PROPOSED TECHNICAL SPECIFICATIONS
REGARDING RELOAD 5/CYCLE 6

JAMES A. FITZPATRICK NUCLEAR POWER PLANT
POWER AUTHORITY OF THE STATE OF NEW YORK

Docket No. 50-333

I. Description of the Changes

Figure 3.1-2

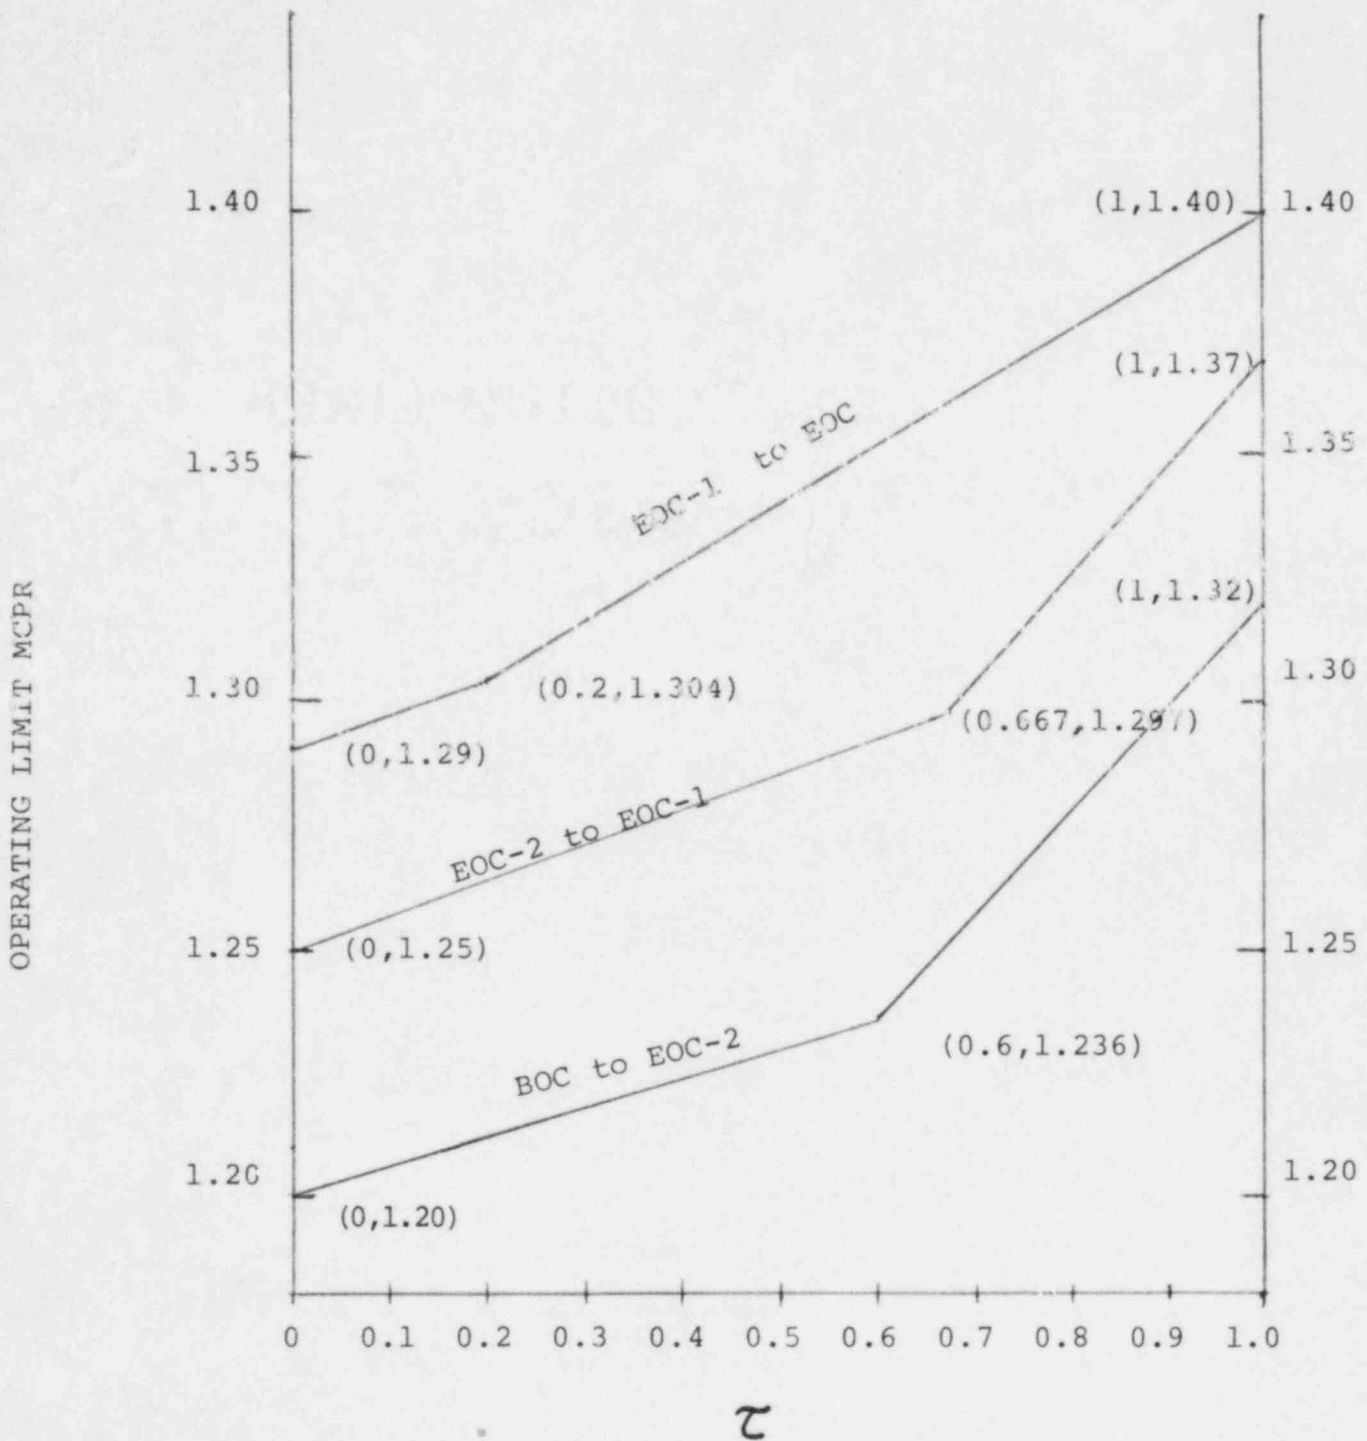
10. A new Figure 3.1-2 on page 47b replaces Figures 3.1-2a b and c, which specify Operating Limit MCPR versus scram time ratio. Since limits for P8x8R fuel can be applied to the entire core, only a single Figure, 3.1-2, is required.

As noted in Section I above, Figure 3.1-2 replaces Figures 3.1-2a, b, and c due to the applicability of P8x8R MCPR limits to the entire core. For Cycle 6, the new figure contains curves for three different exposure ranges (EOC-1 to EOC, EOC-2 to EOC-1, BOC to EOC-2).

Figure 3.5-10

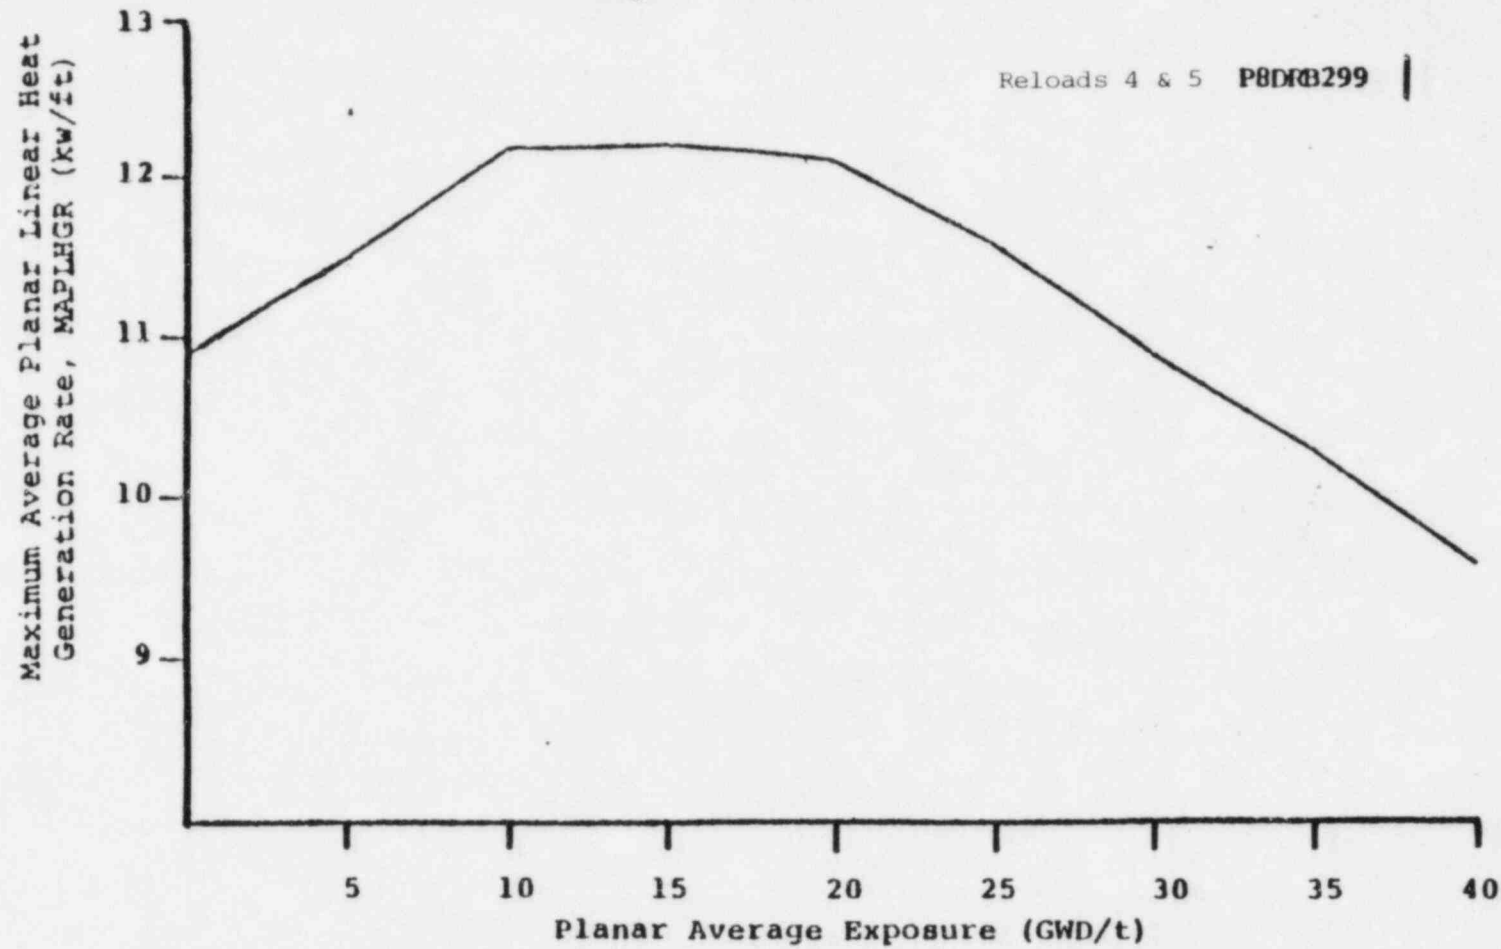
13. Figure 3.5-10, specifying Maximum Average Planar Linear Heat Generation Rate versus Planar Average Exposure, is relabeled to include fuel added for Reload 5. The fuel added in both Reload 4 and Reload 5 is of type P8DRB299.

Figure 3.5-10, specifying maximum Average Planar Linear Heat Generation Rate versus Planar Average Exposure, applies to P8DRB299 fuel. Since this is the fuel type added to the core in both Reload 4 and Reload 5, the same curve is used to represent both reloads.
